PLANNING & ZONING BOARD STAFF REPORT

2419 North Federal Highway

Meeting	File No.	Application Type
May 18, 2026	2025-213-SPR-WAI-LV4 2025-214-USE-PZB	Level 4 Site Plan; Conditional Use, For Free Standing Multiple-Family Housing
Property Owner	Authorized Agent	
Ultra Luxury Townhomes, LLC	Jeffrey Costello, AICP JC Planning Solutions

Provide a recommendation to the City Commission for a Level 4 Site Plan Application, including a Landscape Plan, Architectural Elevations, Four Waivers, an Internal Adjustment, and a Loading Determination, to construct a 47-unit multiple-family townhouse-type condominium development with a mix of two- and three-story buildings; and a Conditional Use to allow free-standing multiple-family development in the General Commercial (GC) zoning district.

Internal Façade (Building A)

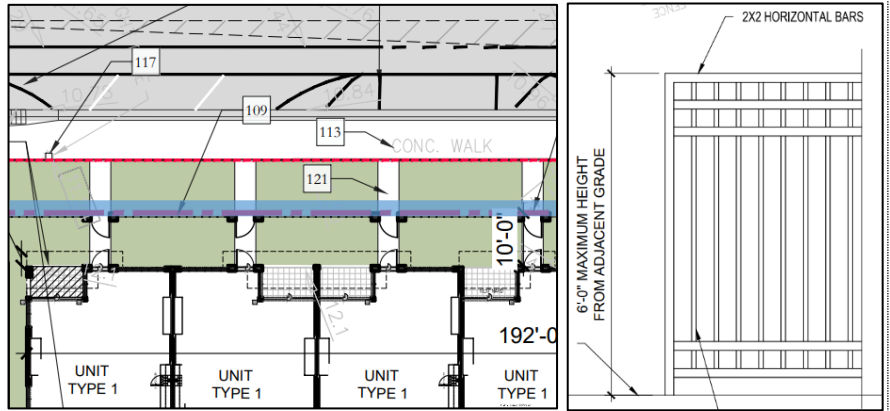
The intent of the townhouse design standards, such as the four-foot offset requirement, is to prevent long rows of repetitive design, reducing the overall mass, and articulating each townhouse unit (shown in blue to the right). Rather than offsetting each townhouse unit, the project proposes to provide a four-foot articulation within each unit (shown in purple to the right).

The offset requirement applies to both the rear and front of the structure; the structures along North Federal Highway appropriately articulate the townhouse mass both to the front and rear similar to the intent of offsetting the townhouse units (shown to the right). All the facades facing the driveways have this four-foot articulation within each townhouse unit, breaking up the overall massing; several rear and side elevations, particularly along the south and east edges, do not provide the same level of articulation as the driveway-facing elevations.

The Board should consider if the proposed four-foot articulation within each unit adequately meets the intent of the offset requirement, or whether the lack of rear and side articulation weakens the request.

3. LDR Section 4.6.9(D)(6)(d): Drive Aisle Width

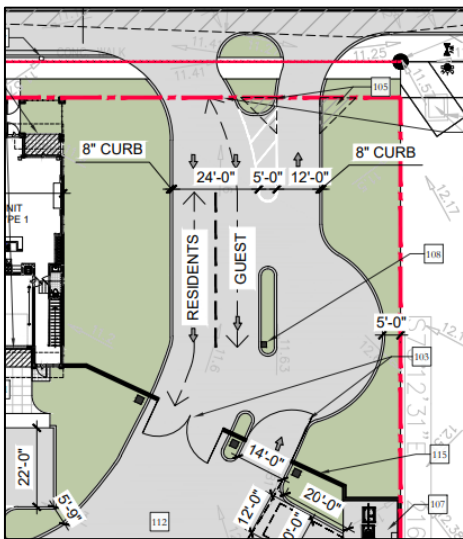
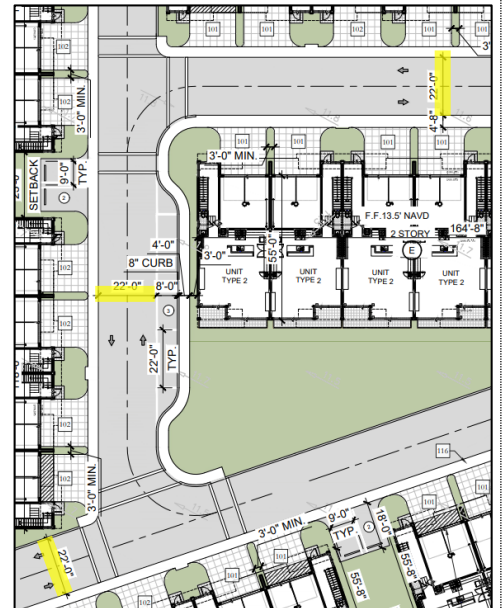
The project proposes 22-foot private drive aisles, whereas the code requires a minimum width of 24 feet. Drive aisle width requirements are established to ensure safe two-way circulation and adequate maneuvering for vehicles backing out of parking spaces. The applicant has proposed a maneuvering diagram that illustrates larger vehicles will be able to effectively maneuver through the site. However, the reduced width occurs in areas where parking is located on both sides, which may create conflict between parked vehicles, backing movements, service vehicles, and emergency access. Fire has also noted potential concerns if a fire truck blocks circulation while accessing a hydrant during an emergency.

The Board should consider whether the reduced drive aisle width will negatively affect maneuverability and safety within the development. The requested reduction applies only to private internal drive aisles and does not directly affect the public right-of-way.

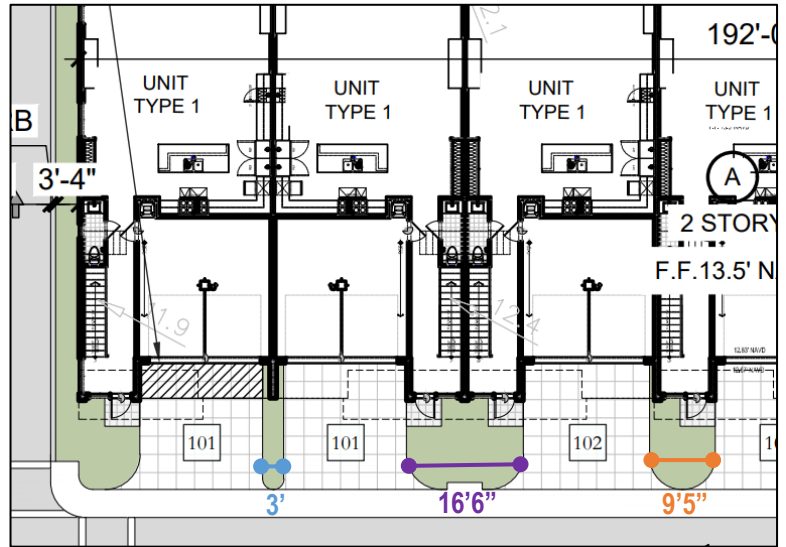
The requested reduction is internal to the site and does not reduce the required perimeter landscape buffers adjacent to North Federal Highway or neighboring properties. The proposed three-foot buffer provides some landscape separation, but less planting area than required by the LDR. The Board should consider whether the overall landscape design, including perimeter buffers, internal planting, and open space, sufficiently offsets the reduced buffer width.

The Board should determine whether the waiver improves the site design or whether the proposed layout is negatively impacting the quality of life for the residences of the overall project.
